Blue Planet Knit Composite Ltd.

5th July and 28th August 2022

Observations

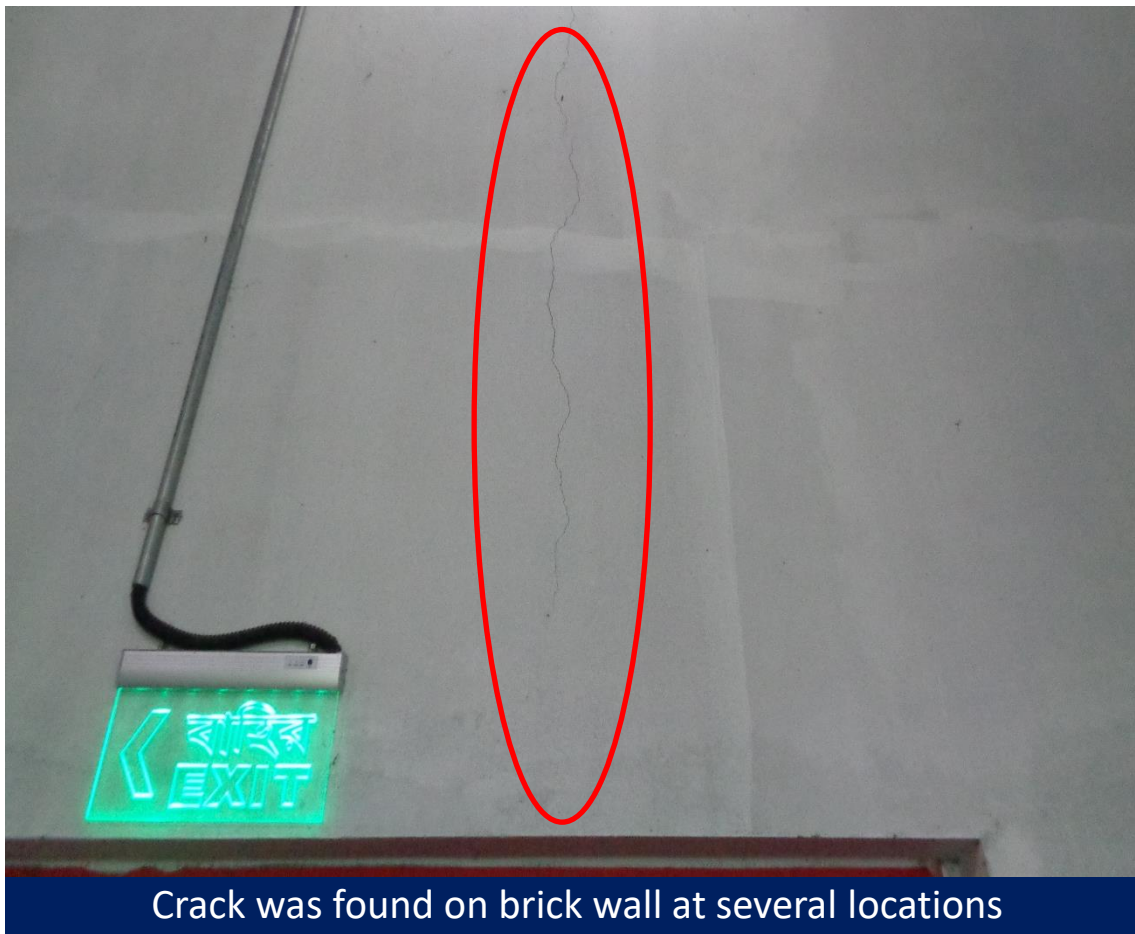
Non-structural elements found unbraced/not anchored

Storage rack found within the building without braced/anchored

Factory is required to brace/anchor all non structural elements.

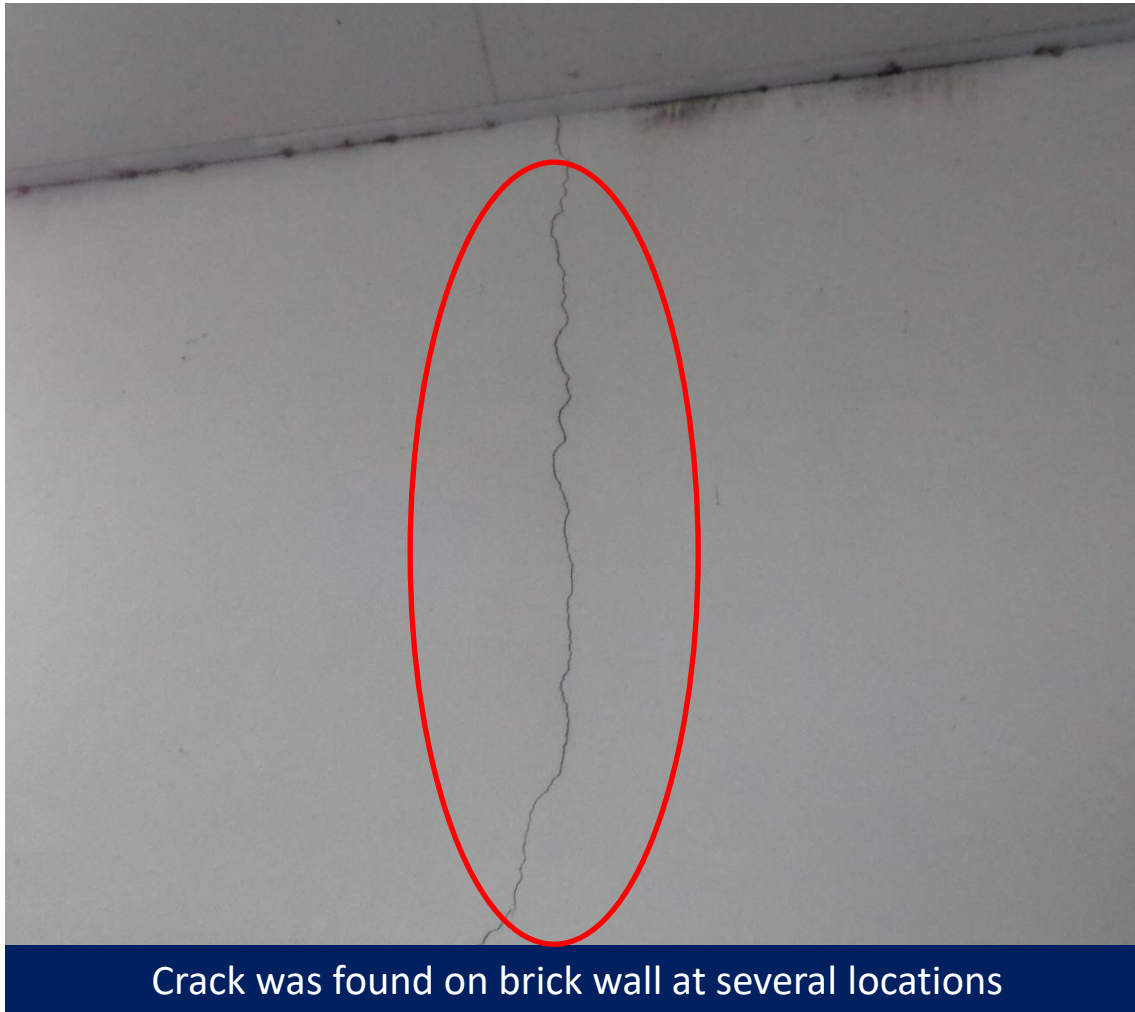
A design report was prepared for Bonded Warehouse Shed which doesn't include the connection adequacy check for the steel connections. Building engineer is required to incorporate all necessary checks including the connection adequacy check in the design report and submit to RSC for review.

Prepared design report doesn't include the connection adequacy check
